ADDENDUM

Project Name: Health Life Safety Work: Roof Replacement at: Barry and Kinderhook Schools

Project Number: 5769

Addendum Number: 1

DWG. NO.
A2.0

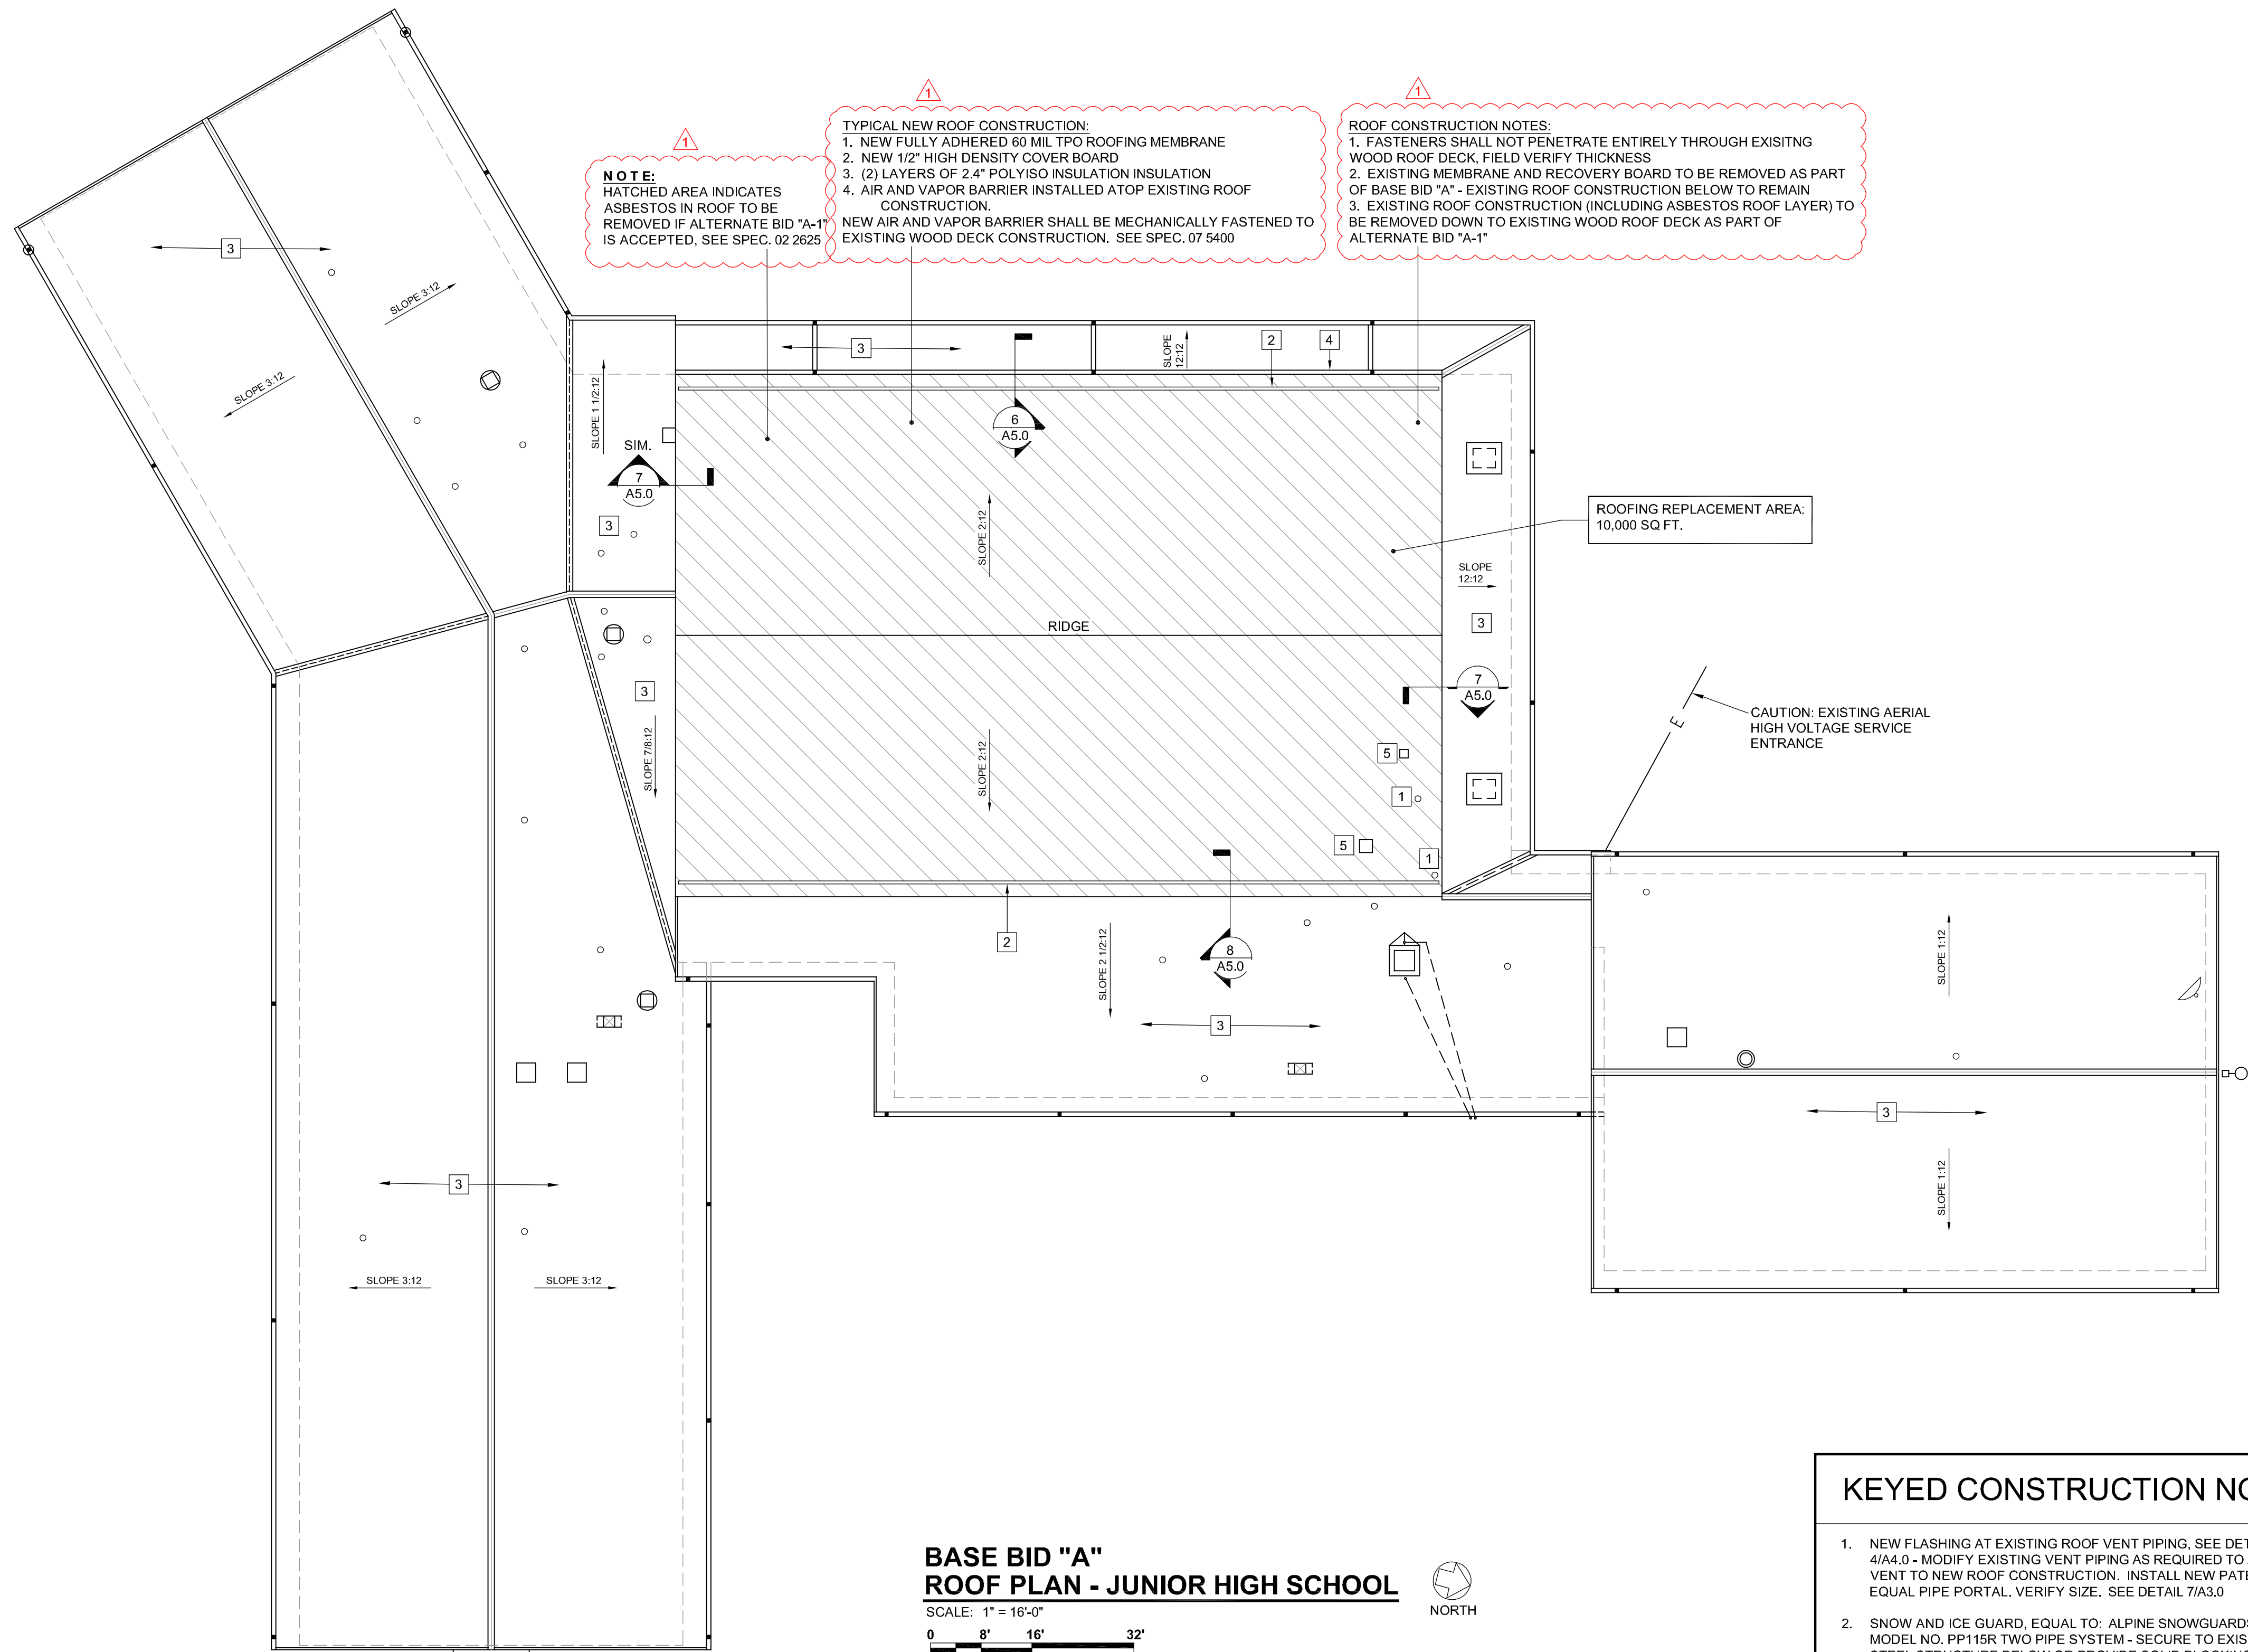
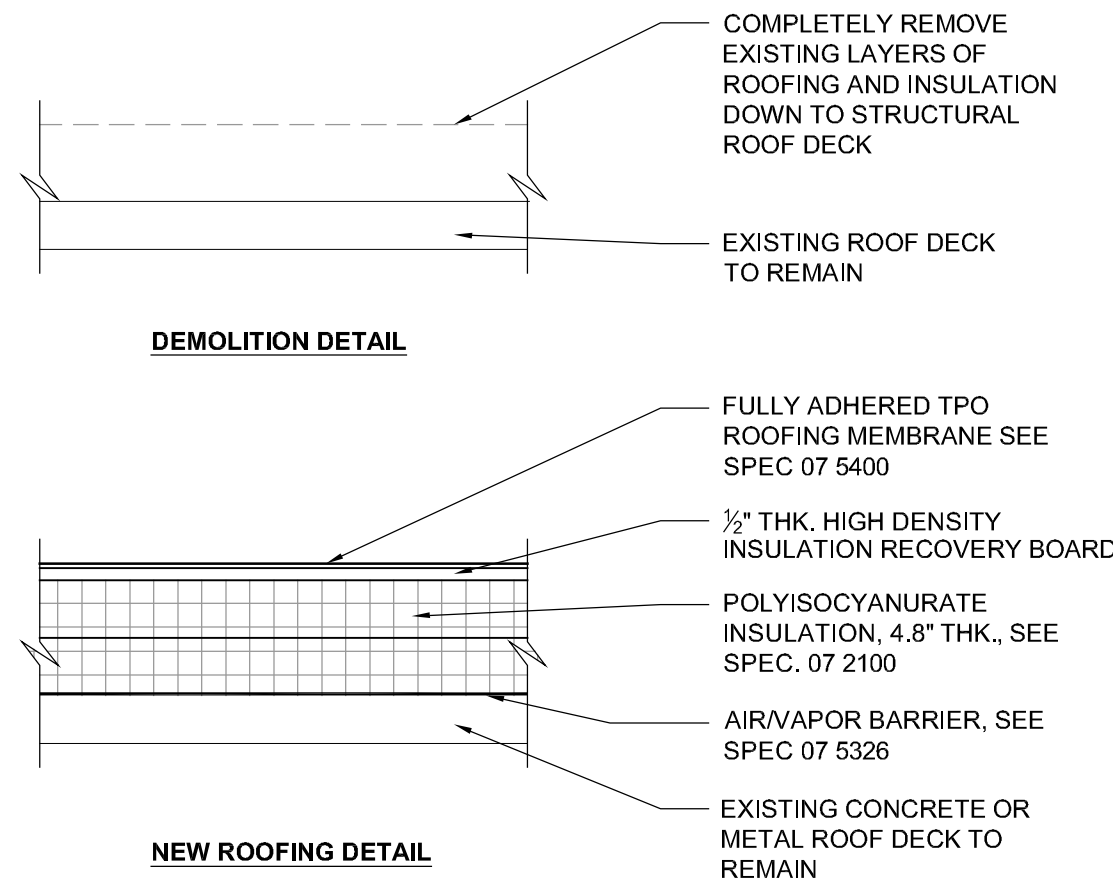
A1.0	Revise:	Remove (6) exhaust hoods at gym roof and infill opening with "like" materials to match existing.
A1.0	Clarify:	Remove the 25,750 S.F. roof area from Alternate Bid "C-1".
A1.0	Revise:	See revised drawing for updated construction notes at upper roof area based on new field verification data.
A2.0	Revise:	Existing roof deck is wood, not metal.
A2.0	Revise:	See notes on revised plan for changes to scope of work for Base Bid "A" and Alternate Bid "A-1".
A4.0, Detail 1	Revise	Detail revised to distinguish between adhered and mechanically fastened insulation.

ROOF AREA KEY PLAN

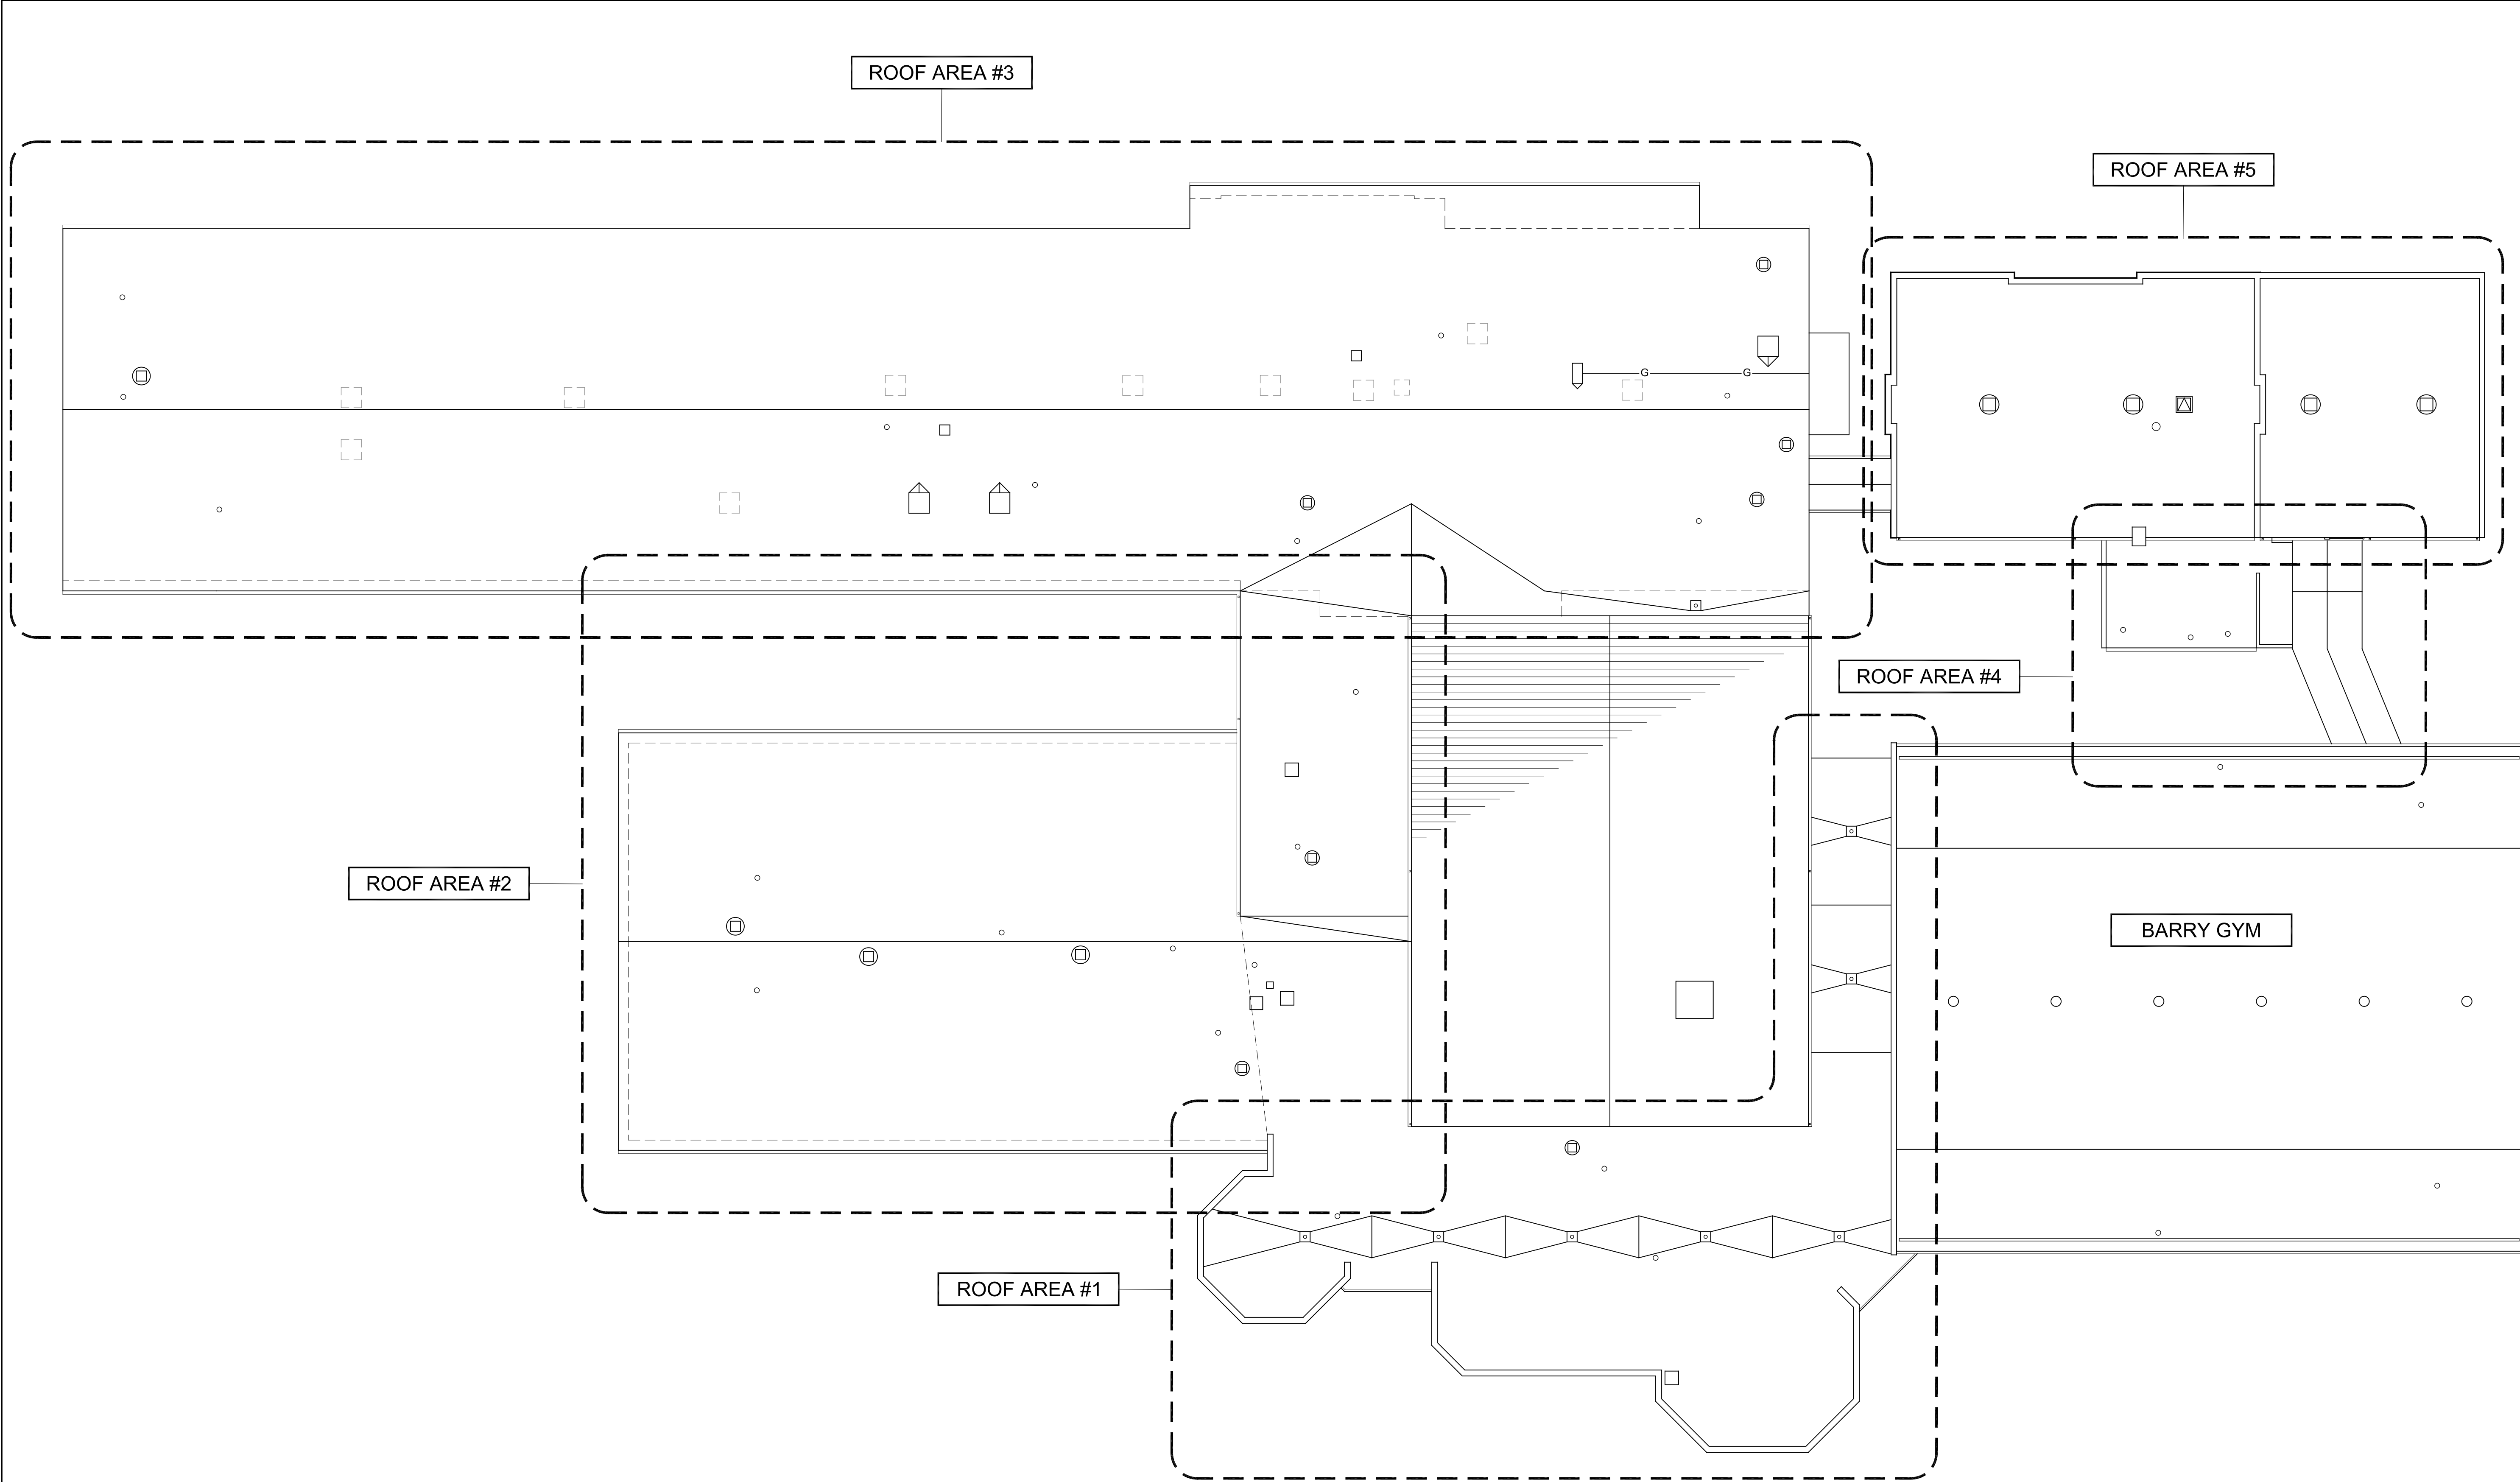
ITEM	DESCRIPTION	NOTES
SPECIFICATIONS:		
Section 00 2115	Add	Section 13 - Examination of Site: Pictures of the existing conditions can be found at the dropbox (copy and paste) link below, see attached Roof Key Plan for reference: https://www.dropbox.com/sh/2qrw5wahsk362uy/AACc_2mi_1UbGqfVAmcbmGfxa?dl=0
Section 00 4200	Revise	Alternate Bid "A-1" - 30 Year TPO Roof for the Kinderhook roof replacement is added to the project. Revised Bid Proposal is attached.
Section 07 5326, Part 3.2(E) Section 07 5400, Part 1.01	Revise	For Base Bids "B" and "C", the polyisocyanurate insulation shall be mechanically fastened.
DRAWINGS:		
A1.0	Revise	Roof areas have been revised as noted.
A1.0	Revise:	Construction Note #28 added to the 25,750 S.F. roof area - this area of roof has existing metal roof and flute insulation to remain.
